July 21, 1977

Enclosed please find information concerning the spent fuel pool structural analysis which was informally requested by the Engineering Branch, Operating Reactors Division, U.S. Nuclear Regulatory Commission. This information serves to clarify the information in our response to question No. 1 of our May 24, 1977 submittal.

THREE MILE ISLAND NUCLEAR STATION UNIT 1
SPENT FUEL POOL MODIFICATION
REQUEST FOR ADDITIONAL INFORMATION

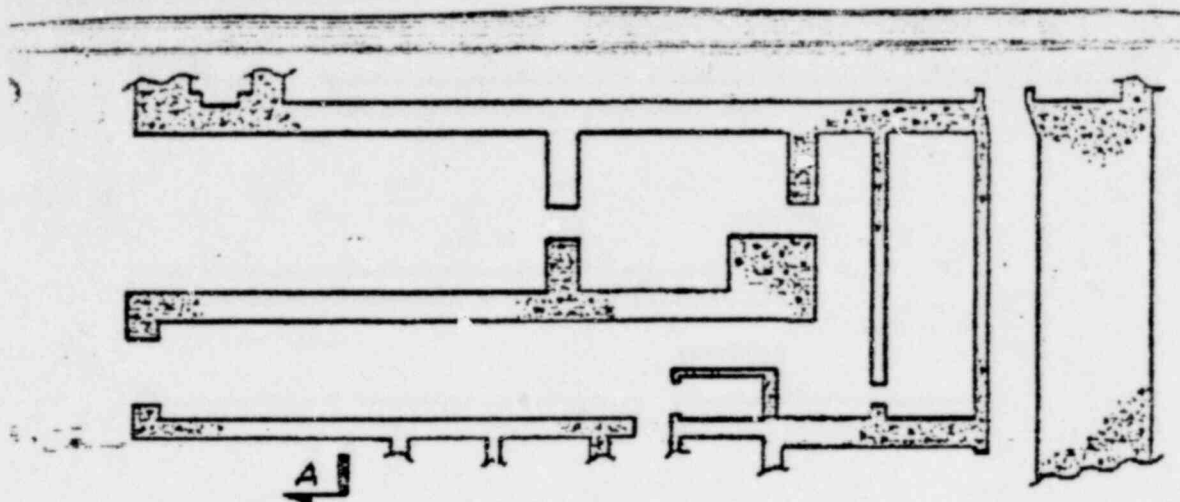
When considering thermal loads due to T_0 , verify that load combinations c and d are satisfied. When considering the effects of T_0 demonstrate that at the critical sections the concrete stresses do not exceed $0.85 f'_c$, and the rebar steel strains do not exceed twice the yield strain. Demonstrate that the crack width at these critical sections will not damage the liner. Discuss the effects of redistribution of the forces and moments in the structure at these critical sections where the cracks occur.

With regard to a discussion of the redistribution of internal forces and moments due to thermal "loads", a schematic representation of section 2 is illustrated below:

In this case, because of the temperature distribution, the B Portion restrains the A Portion. When vertical cracking occurs in the B Portion, the tensile forces of the B Portion are reduced and also relieve the compressive forces of the A Portion. Because of equilibrium requirements between the two portions, Portion A will never go into tension, and the tensile strains in the B Portion reinforcement will not exceed the previously calculated upper bound thermal axial strain.

FIGURE - 3 - MAXIMUM NEGATIVE MOMENT

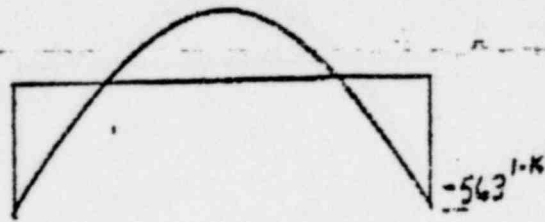
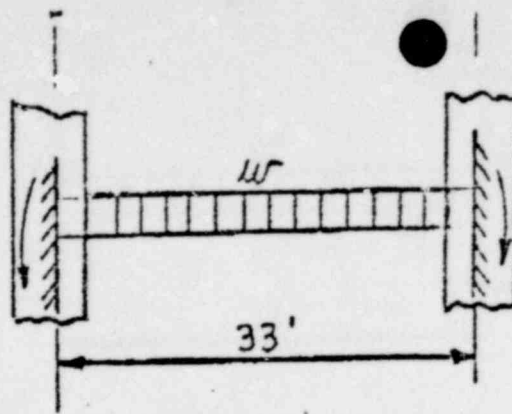
For Critical Section 1, verify that the pool slab can withstand load combinations a, b, c & f, assuming one way slab action in the East-West direction.

Considering a unit strip in the East-West direction, conservative upper bounds can be estimated for both the negative and positive bending moments. Considering first the negative moment and referring to Figure 3, the maximum negative moment is -563 ft-k based on a center to center fixed span of 33 feet. With reference to Figure 4 the maximum positive moment is +608 ft-k based on a clear simple span of 28 feet.

FIGURE 7

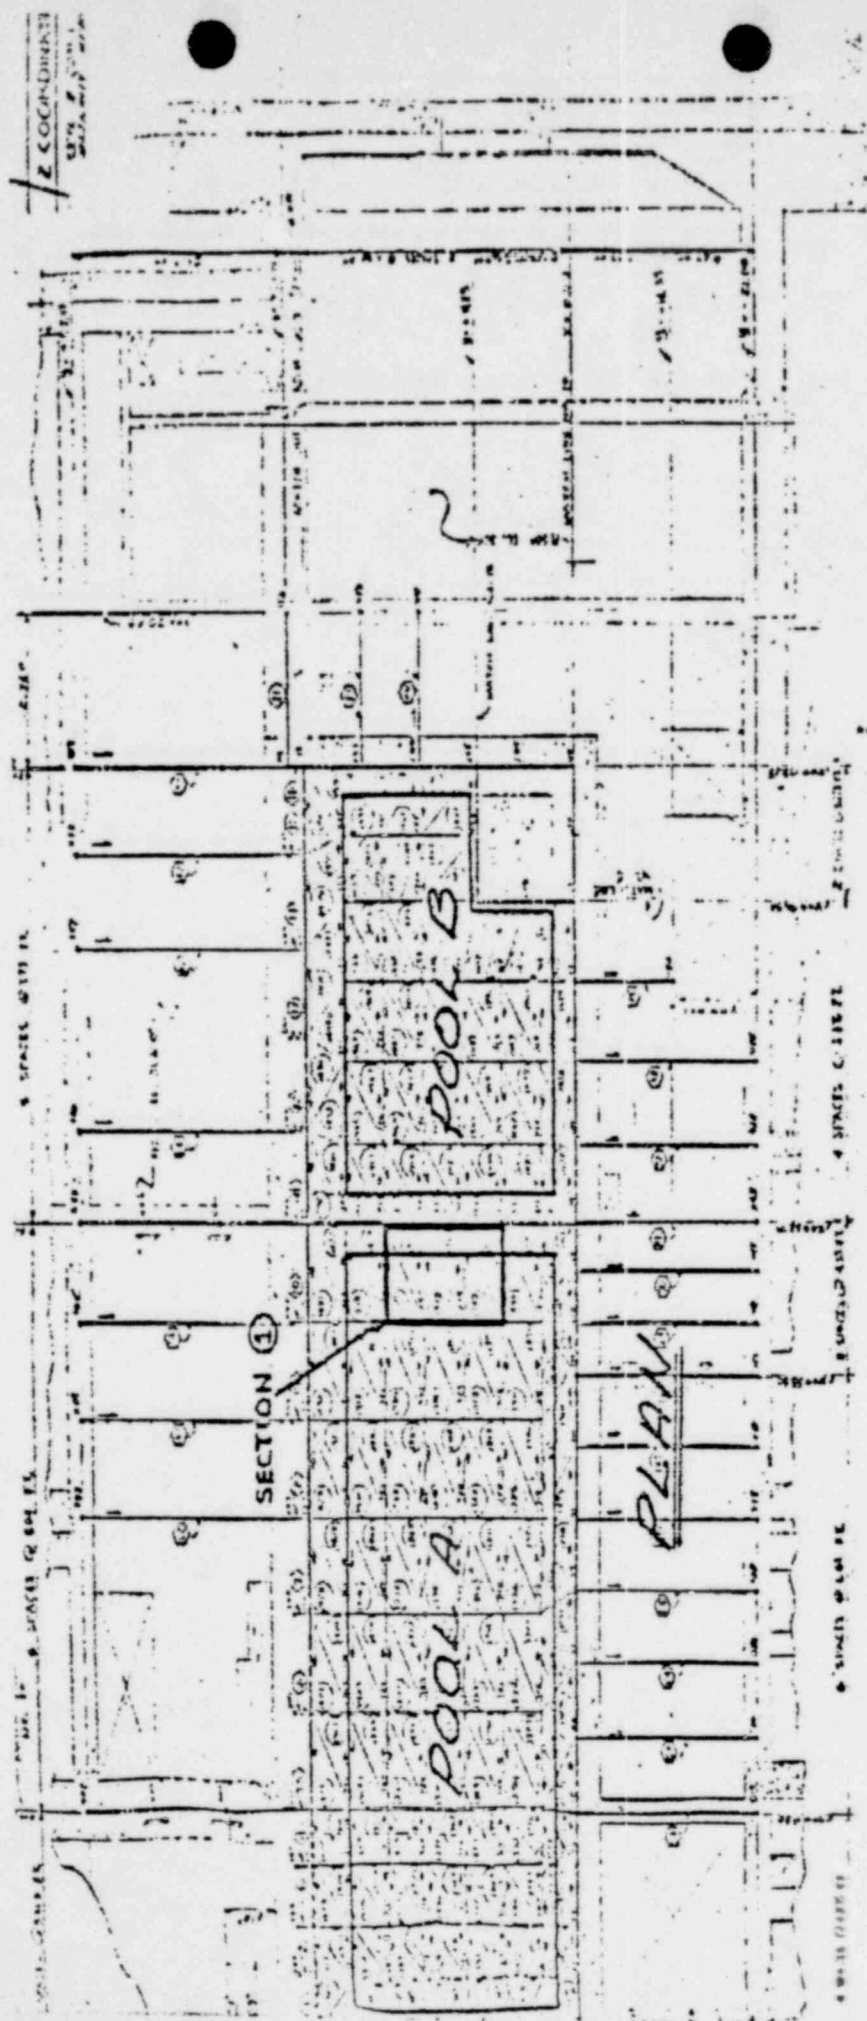
Verify that the crack width at Critical Section 1 will not result in damage to the pool liner.

The region identified in the May 24, 1977 submittal as "Critical Section 1" is shown in Figure 7. The internal forces and moments predicted by the elastic analysis indicate that nominal cracking and redistribution will take place locally in the vicinity of Critical Section 1. Such localized effects will have

FIGURE 9

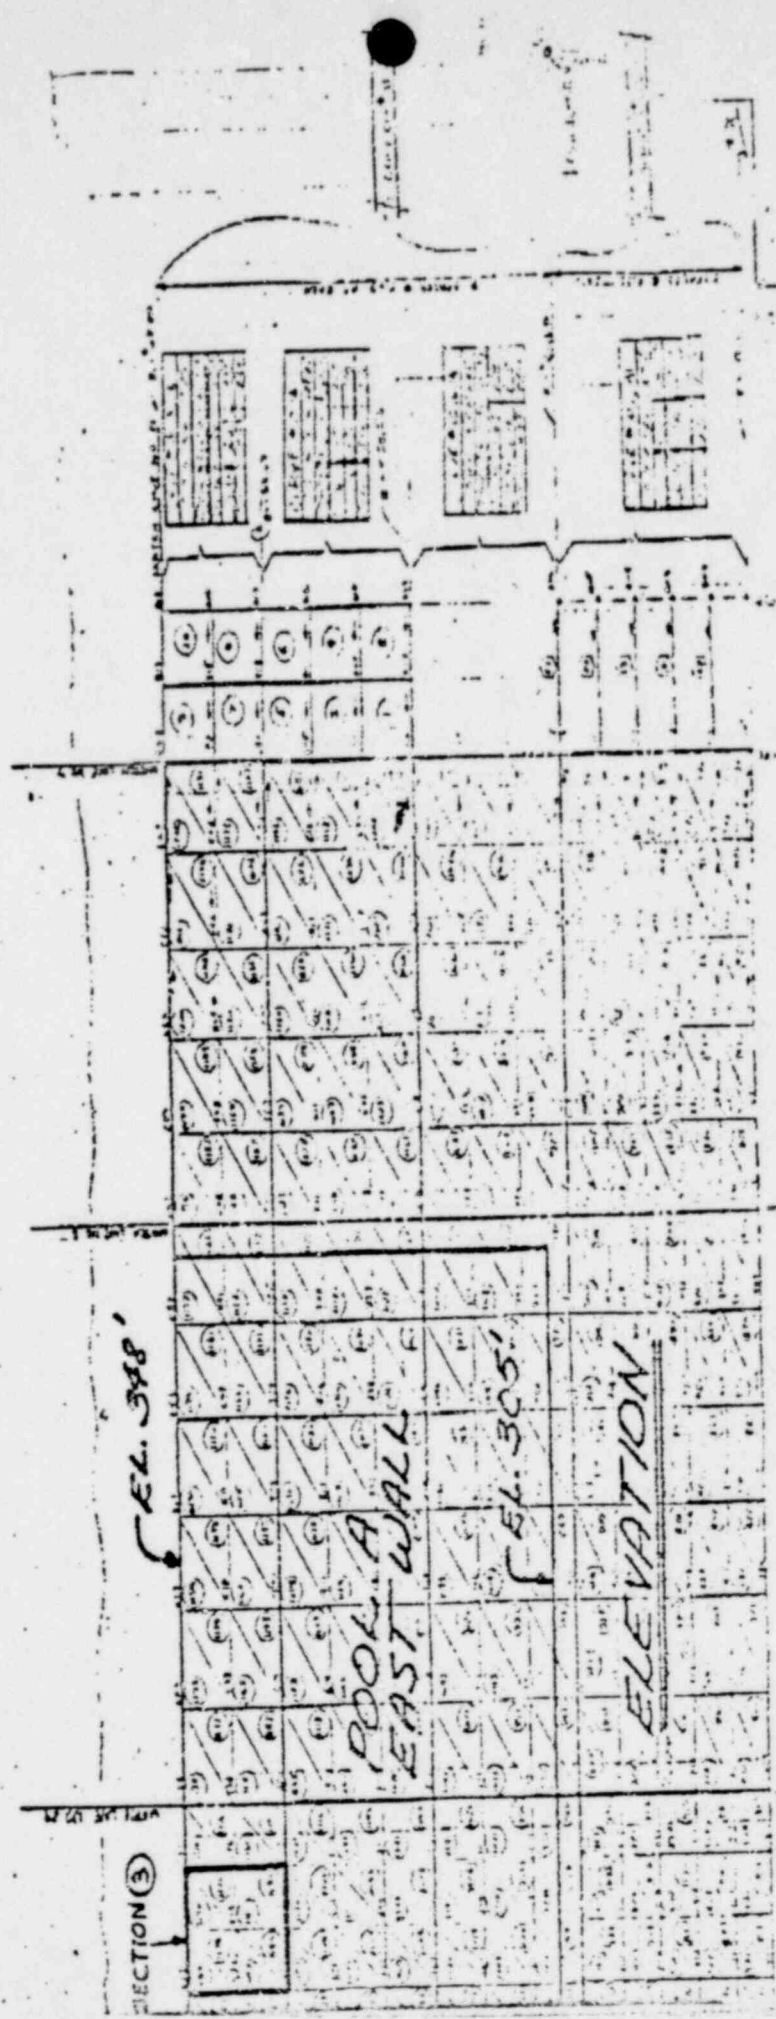
With regard to Critical Sections 2, 3 and 4, verify that the required section capacity does not exceed existing section capacity for load combinations c, d, g and h, neglecting thermal loads.

The regions identified in the May 24, 1977 submittal as "Critical Sections 2, 3 and 4" are shown in Figures 8, 9 and 10. Tables 1, 2 and 3 provide required capacities for load combinations c, d, g and h (neglecting thermal loads) for Critical Sections 2, 3 and 4, respectively. Comparison of the required capacities to the available capacities given in Figures 11, 12 and 13 indicates that all available capacities exceed required capacities.

Furthermore, as can be seen in Figures 8, 9 and 10, the redistribution of internal forces as a result of cracking will be confined to the localized areas shown. Hence, the thermal loads are dissipated at very small strain values and the structural integrity of the pool complex is adequate.
